Re: Energy Conservation Standards for Small, Large, and Very Large Air-Cooled Commercial Package Air Conditioning and Heating Equipment [Docket Number EERE-2013-BT-STD-0007]

These comments are submitted by the Air-Conditioning, Heating, and Refrigeration Institute (AHRI) in response to the U.S. Department of Energy's (DOE) notice of proposed rulemaking (NOPR) on the Energy Conservation Standards for Small, Large, and Very Large Air-Cooled Commercial Package Air Conditioning and Heating Equipment appearing in the *Federal Register* on September 30, 2014. 79 Fed. Reg. 58,948 (proposed Sept. 30, 2014) (to be codified at 10 C.F.R. pt. 431).

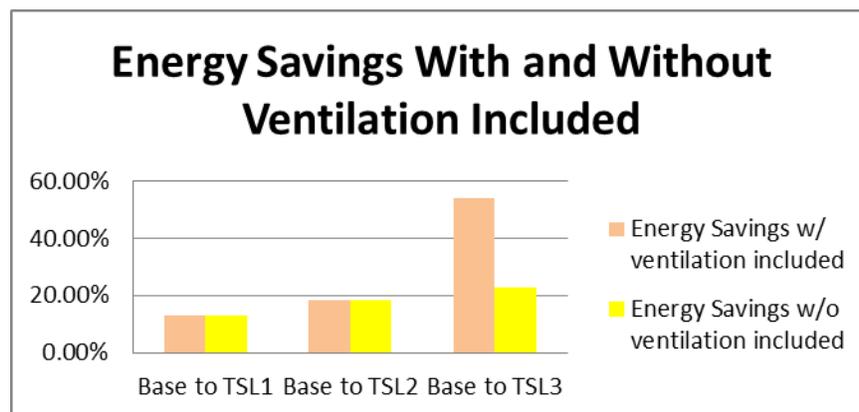
The modeling used to establish increases in minimum efficiency is not appropriate. The equipment affected by this rulemaking represents the most technologically advanced products regulated by the DOE. Assumptions that were made do not accurately reflect the equipment's operating conditions in the field and are not in agreement with current testing standards, such as the disabling of economizers, inclusion of ventilation air, and IEER/COP correlation. The following section discusses this in greater detail.

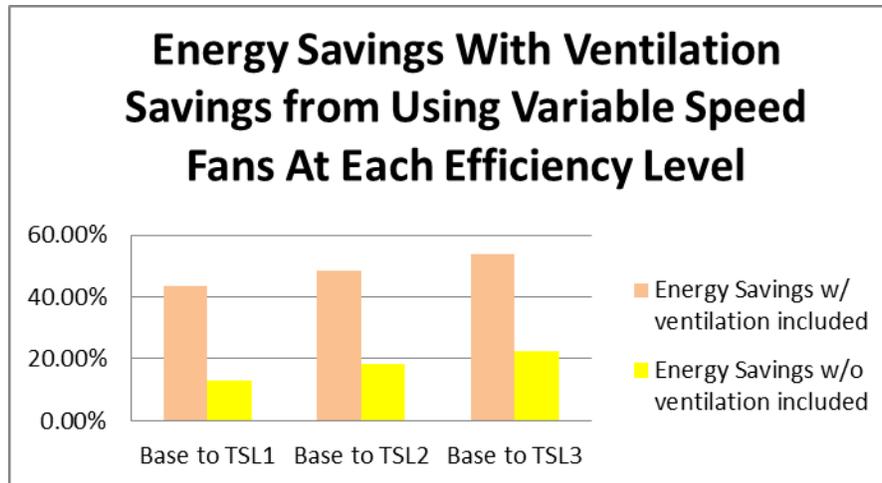
- Fan speed is controlled in the modeling using ambient temperature and the controls associated with variable speed fans are not included. The negative impact on mechanical efficiency from high load and low fan speed is not considered.
- The energy used for ventilation or when the fan runs constantly is driving energy savings and establishing bias for more efficient products. The products in this category can provide ventilation air; however, as discussed above this is not covered in the Federal test procedure (AHRI 340/360 standard). DOE is including ventilation at each efficiency level, but because they did not use a variable speed fan motor at EL1 or EL2, energy saving at EL3 and EL4 is calculated incorrectly. A comparison of energy savings with and without ventilation included is shown below.

- ASHRAE 90.1-2013 requires multiple speed blowers on equipment in this capacity range. Because ASHRAE contains this requirement, DOE's failure to include it in the modeling means that DOE's analysis is of equipment that is not in fact, and will not be, the equipment sold in the relevant markets. If the DOE modeling included this design feature at EL1 and EL2, the energy analysis changes dramatically and the energy savings from EL1 to EL3 does not change substantially. The costs associated with EL3 are much more significant; however, and the benefit does not outweigh the cost. A comparison of energy savings using variable speed blowers at each efficiency level is shown below.
